Access Compliance Report

Public Rights-of-Way

Intersection ID: 14982	Main Street: ARENA_BV	Cross Street: COLISEUM_DR	Location: S
ADA ID: 136930ACC1FB	Ramp Type: Perp	Initial Pass/Fail: Fail	Overall Compliance: No
		Severity Score: 1.25

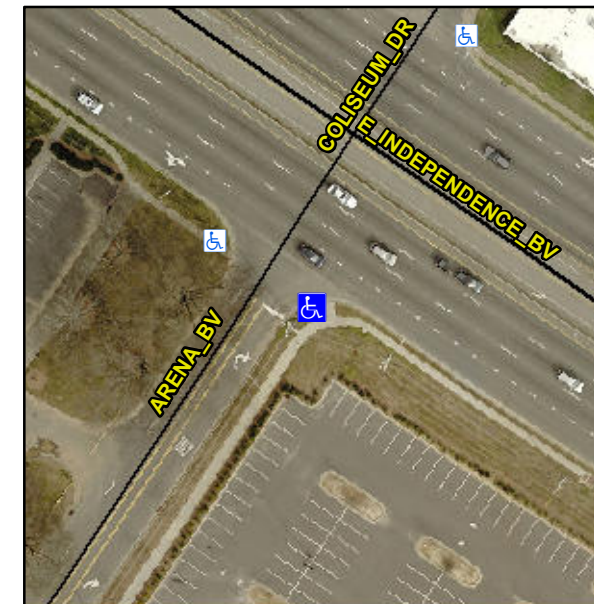
Not Found, R304.5.3

Compliance	Description	Data	Compliance	Description	Data
N/A	Ramp Length (in)	96.0	Yes	Ramp Slope (%)	5.8
Yes	Ramp Width (in)	56.0	No	Ramp XSlope (%)	4.9
N/A	Flare Type LT	N/A	N/A	Flare Type RT	N/A
N/A	Flare Slope LT (%)	N/A	N/A	Flare Slope RT (%)	N/A
N/A	Flare Traversable LT?	N/A	N/A	Flare Traversable RT?	N/A
N/A	Landing Length (in)	N/A	N/A	DWS Provided?	N/A
N/A	Landing Width (in)	N/A	N/A	DWS Contrast?	N/A
N/A	Landing Slope (%)	N/A	N/A	DWS Length (in)	N/A
N/A	Landing X Slope (%)	N/A	N/A	DWS Full Width?	N/A
N/A	Landing Curb? (Y/N)	N/A	N/A	DWS Offset (in)	N/A
N/A	Shared Landing?	N/A			
N/A	Gutter Ponding?	N/A	N/A	Gutter Slope (%)	N/A
N/A	Gutter Lip Ht (in)	N/A	N/A	Gutter X Slope (%)	N/A
N/A	Painted X Walk1?	No	N/A	Painted X Walk2?	N/A
	X Walk 1 Direction	To NW		X Walk 2 Direction	N/A
N/A	X Walk 1 Width (in)	N/A	N/A	X Walk 2 Width (in)	N/A
	X Walk 1 Slope (%)	0.7		X Walk 2 Slope (%)	N/A
	X Walk 1 X Slope (%)	5.2		X Walk 2 X Slope (%)	N/A

Remove & Replace Entire Ramp.
